REVISION TRANSMITTAL

This sheet transmits Revision 1 to SB750-27-69, which:

FLIGHT CONTROLS - INSTALLATION OF THE HORIZONTAL STABILIZER TRIM POSITION SENSOR AND SPLINE SHAFT ENGAGEMENT HARDWARE

SB750-27-69
Page 1 of 9

Figure 1. Installation of Sensor and Spline Shaft Engagement Hardware (Sheet 2)

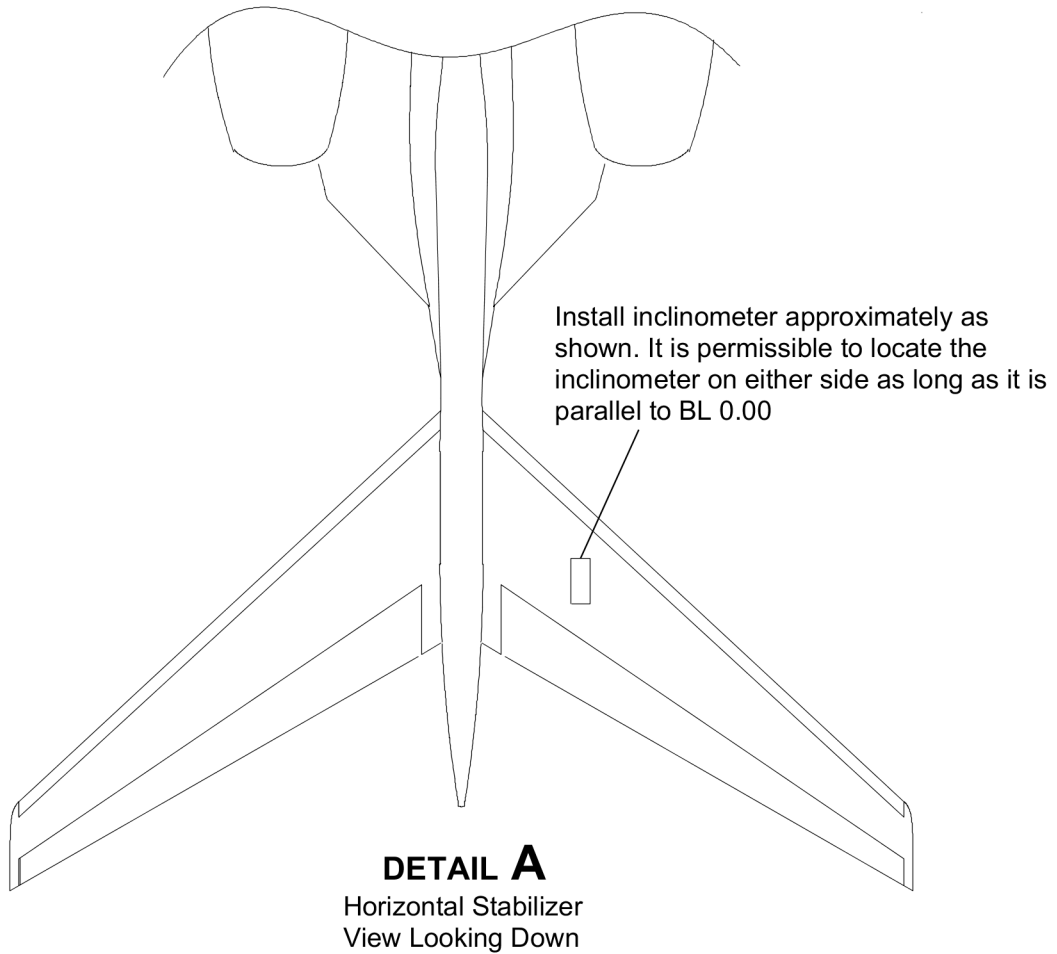
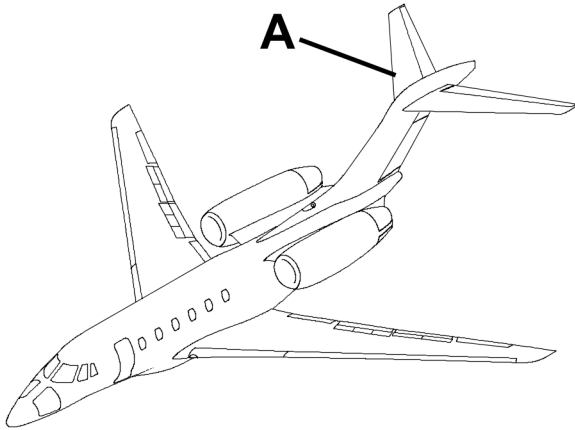
- A. Changes the part number of the Plate from 6793042-204 to 6793042-206 in Step 4.E and 4.F
- B. Changes the part number of the Stabilizer Trim Position Sensor from 3G-212B to 3G5-212D in Figure 1, Sheet 2.
